RECORD OF DECISION

Operable Unit Two
Old Roosevelt Field Contaminated Groundwater Area Superfund Site
Nassau County, New York

United States Environmental Protection Agency
Region 2
New York, New York
March 2018

TCE PCE

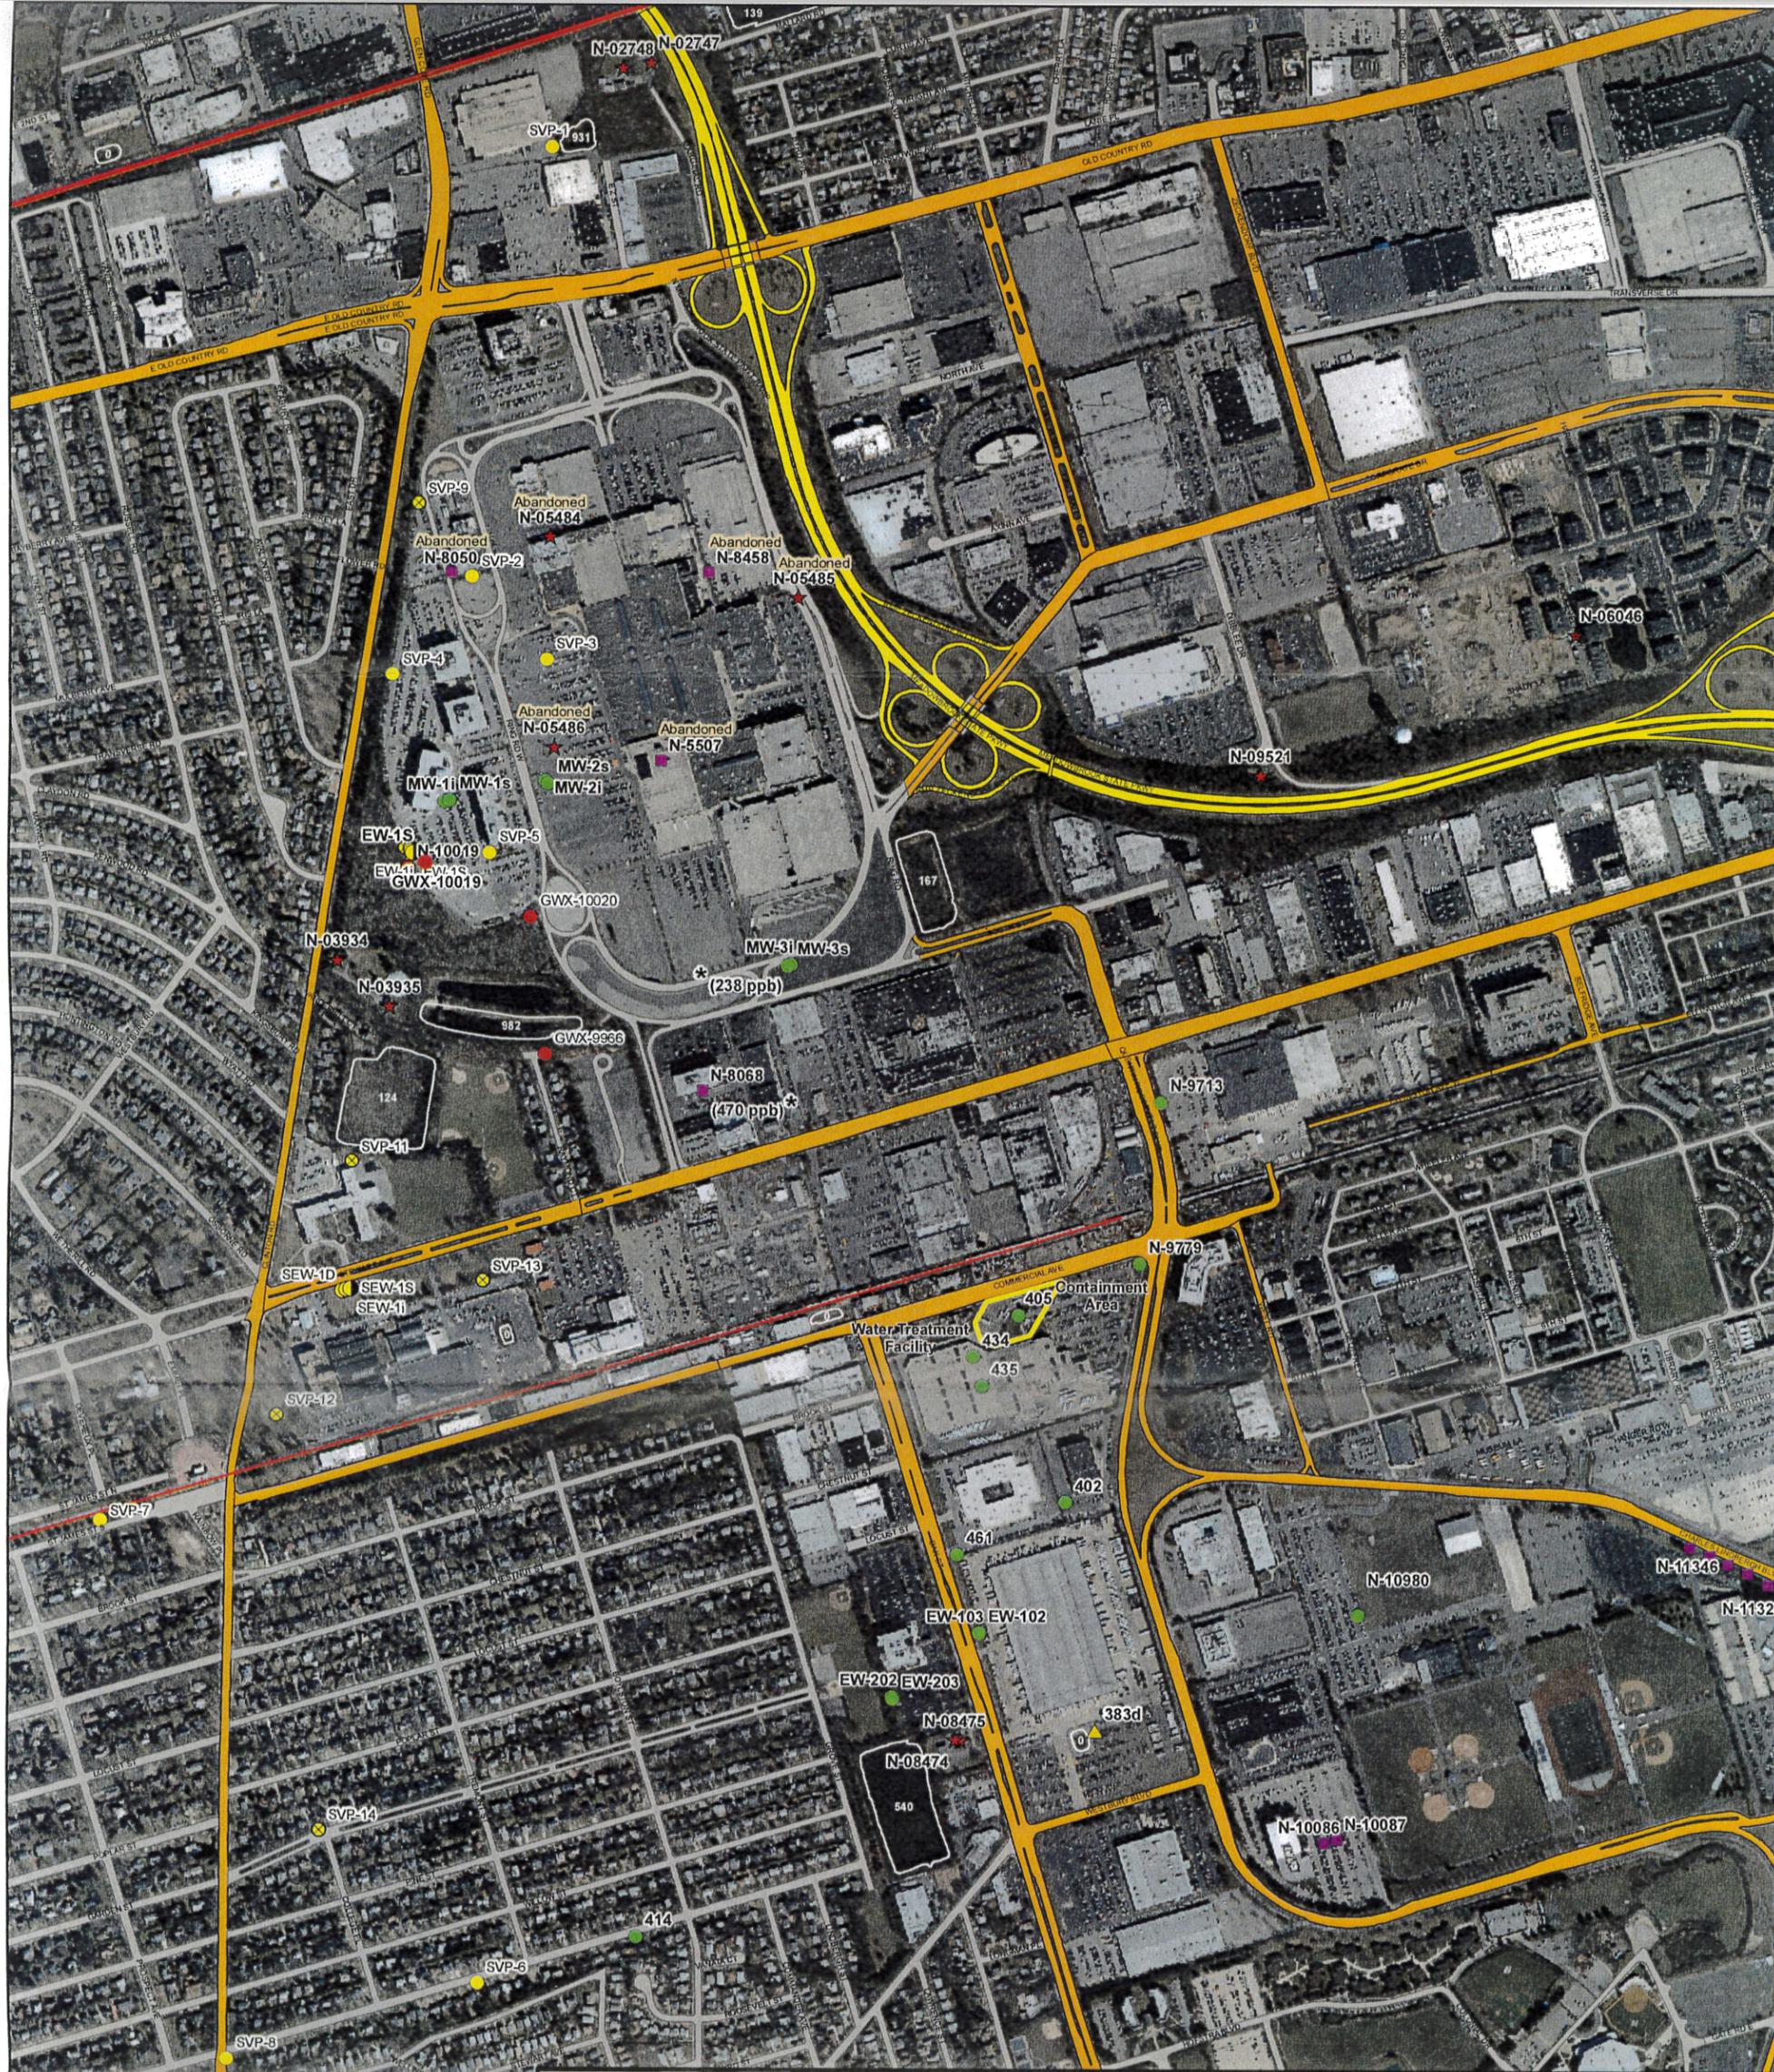
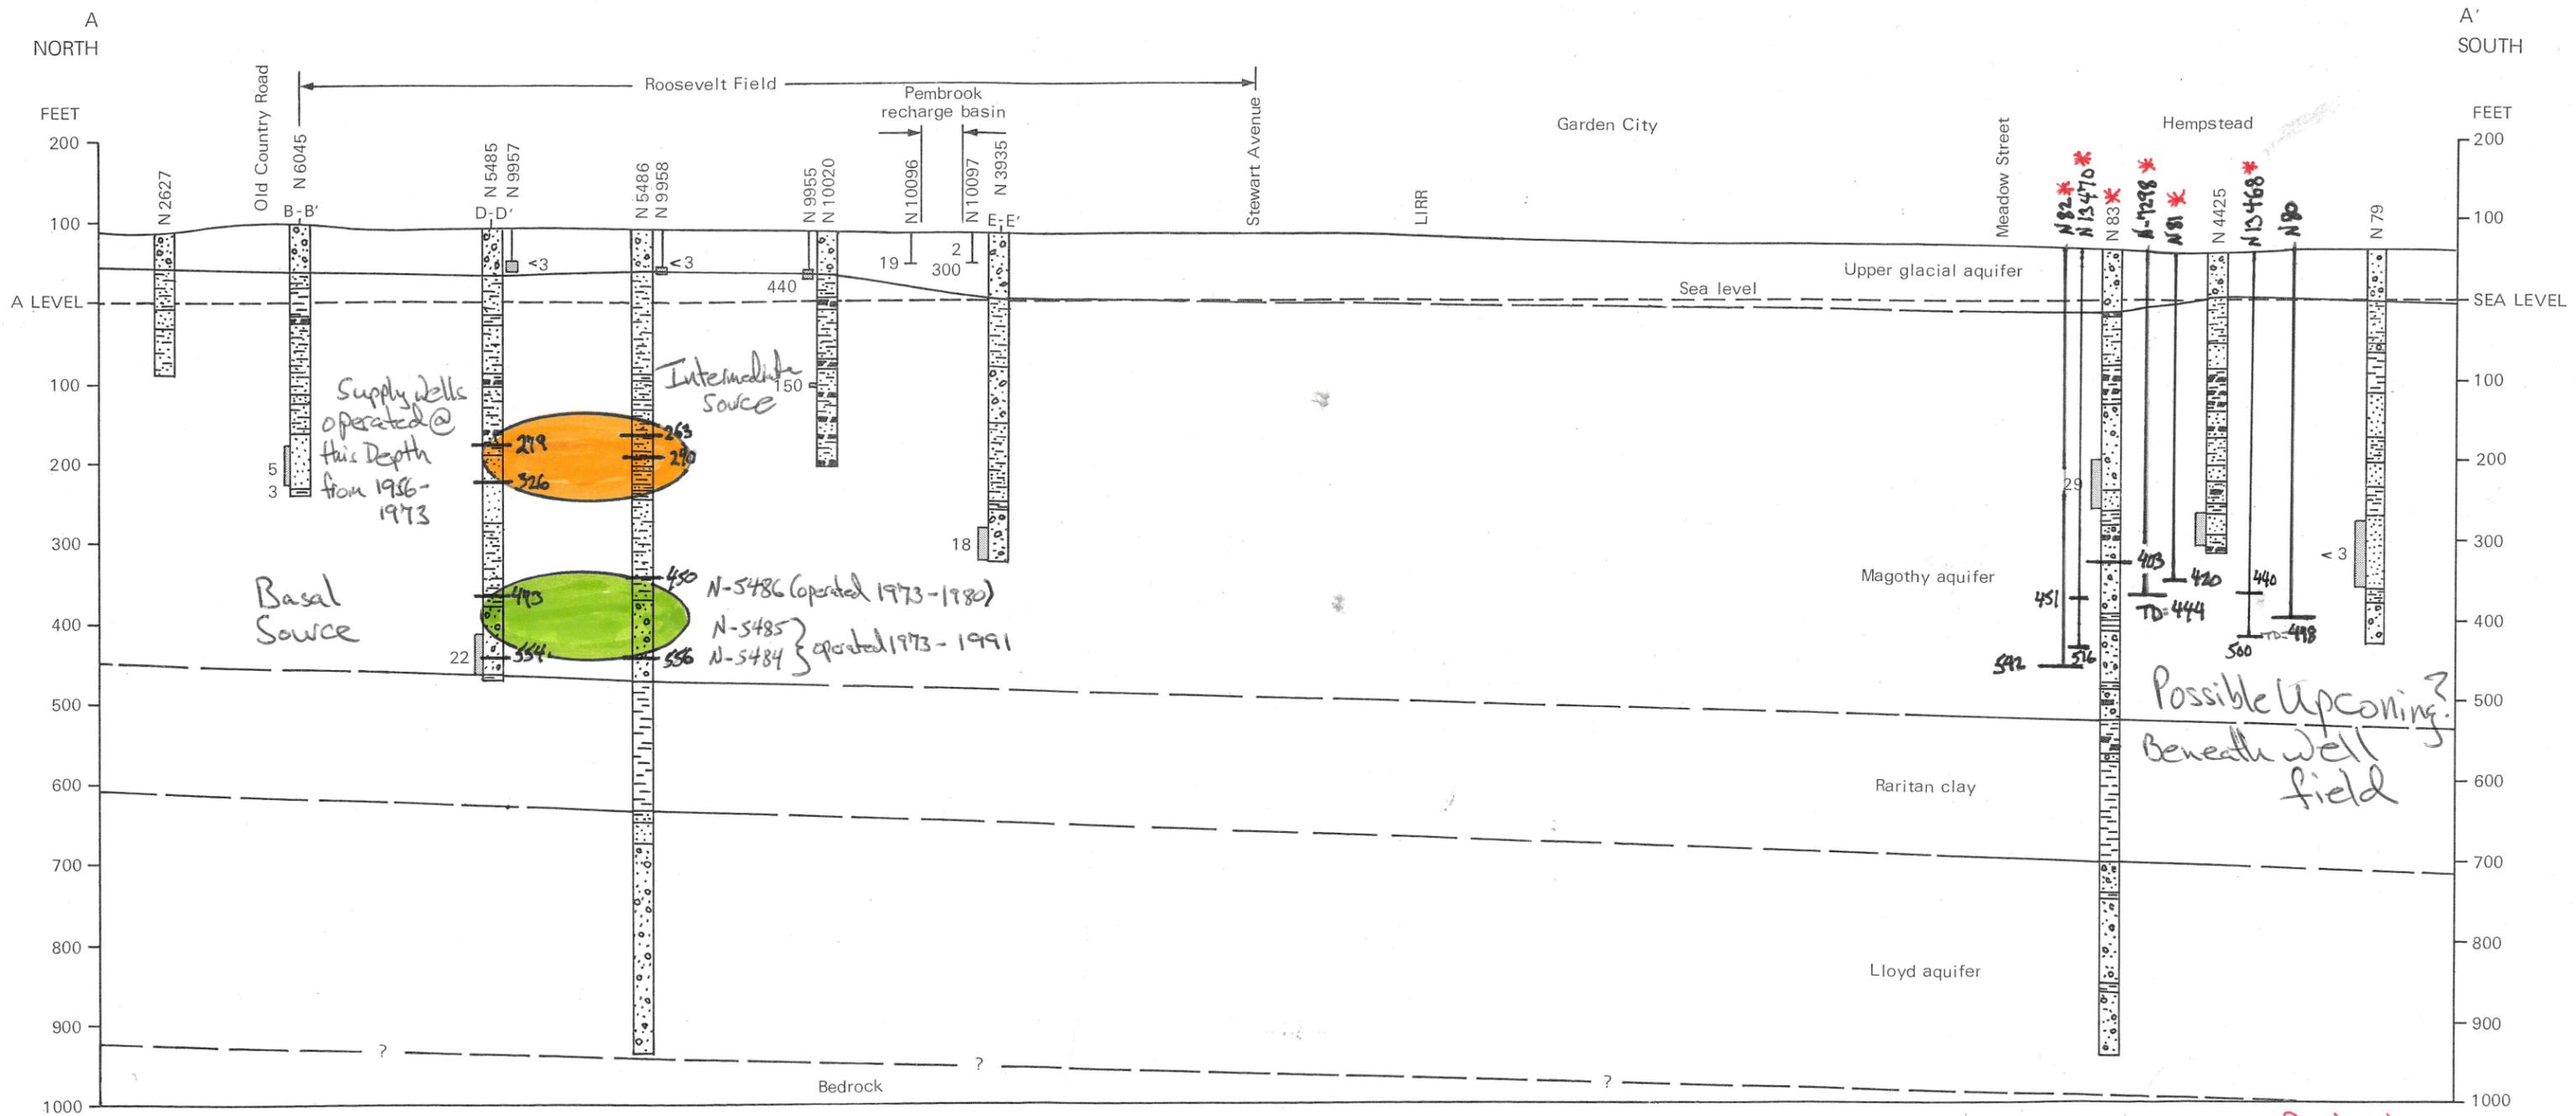
Comment # 9: A representative from Nassau County Department of Public Works expressed general agreement with both the conceptual model proposed for the Site and the identification in the RI Report of the historic source area located in the intermediate zone (250 to 400 feet below ground surface). The representative requested that EPA consider modifications to the conceptual site model and interpretation of the intermediate and deep zones of contamination based on construction and operation details provided for public supply and cooling wells in the area.

Response to Comment # 9: The comments in support of the conceptual model and the historic source location are noted. Updating the 3-D finite element groundwater model for conditions in the 1970s to simulate contaminant fate and transport would be challenging, as EPA is not aware of data from the 1970s on the extent of the contamination in the vicinity of the supply and cooling wells identified, or on the level of contamination between the historical sources and the wells. In addition, investigating and compiling pumping data from the public supply and cooling wells during that period would require a significant effort, with uncertainty as to the usefulness or limitations of the simulation without representative data, and is not necessary for purposes of the selected remedy.

EPA recognizes the usefulness of conducting synoptic water level measurements during high stress summer and fall conditions with Uniondale Public Supply Wells, N-8474 and N-8475, in operation in calibrating and updating the existing groundwater flow model to support the design of the location and screen interval of the groundwater extraction wells for the OU2 selected remedy. EPA expects to coordinate with the Nassau County Department of Public Works during the remedial design when the Agency develops the sampling plans and the long-term groundwater monitoring program for OU2.
